Access Compliance Report

Public Rights-of-Way

Intersection ID: 44450	Main Street: BAYVIEW_PY	Cross Street: DONNELLSON_COMMON_CT	Location: SW
ADA ID: 64E9F682C856	Ramp Type: PerpDiag	Initial Pass/Fail: Fail	Overall Compliance: No
Codes/Mitigation Info/Possible Solution		Field Measurements/Component Compliance	
Severity Score: 8.75

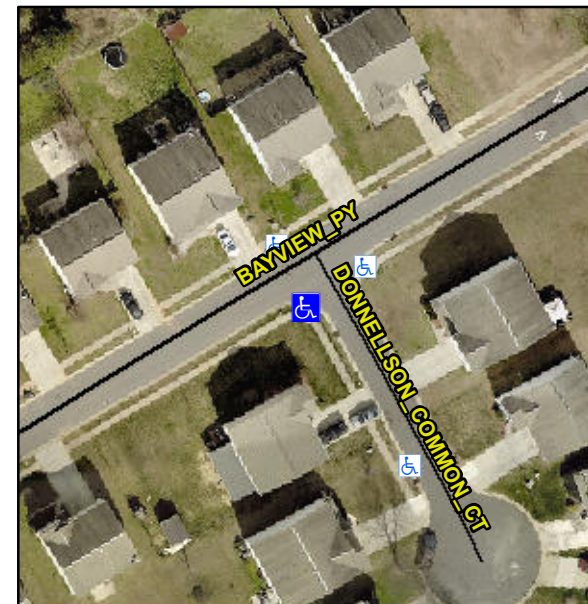
Not Found, R304.5.1

Compliance	Description	Data	Compliance	Description	Data
N/A	Ramp Length (in)	49.0	Yes	Ramp Slope (%)	8.0
No	Ramp Width (in)	40.0	Yes	Ramp XSlope (%)	1.4
N/A	Flare Type LT	N/A	N/A	Flare Type RT	N/A
N/A	Flare Slope LT (%)	N/A	N/A	Flare Slope RT (%)	N/A
N/A	Flare Traversable LT?	N/A	N/A	Flare Traversable RT?	N/A
N/A	Landing Length (in)	N/A	N/A	DWS Provided?	N/A
N/A	Landing Width (in)	N/A	N/A	DWS Contrast?	N/A
N/A	Landing Slope (%)	N/A	N/A	DWS Length (in)	N/A
N/A	Landing X Slope (%)	N/A	N/A	DWS Full Width?	N/A
N/A	Landing Curb? (Y/N)	N/A	N/A	DWS Offset (in)	N/A
N/A	Shared Landing?	N/A			
N/A	Gutter Ponding?	N/A	N/A	Gutter Slope (%)	N/A
N/A	Gutter Lip Ht (in)	N/A	N/A	Gutter X Slope (%)	N/A
N/A	Painted X Walk1?	No	N/A	Painted X Walk2?	No
	X Walk 1 Direction	To E		X Walk 2 Direction	To N
N/A	X Walk 1 Width (in)	N/A	N/A	X Walk 2 Width (in)	N/A
	X Walk 1 Slope (%)	0.9		X Walk 2 Slope (%)	5.3
	X Walk 1 X Slope (%)	0.3		X Walk 2 X Slope (%)	1.3

Remove & Replace Curb Ramp With Two New Directional Ramps or Equivalent.
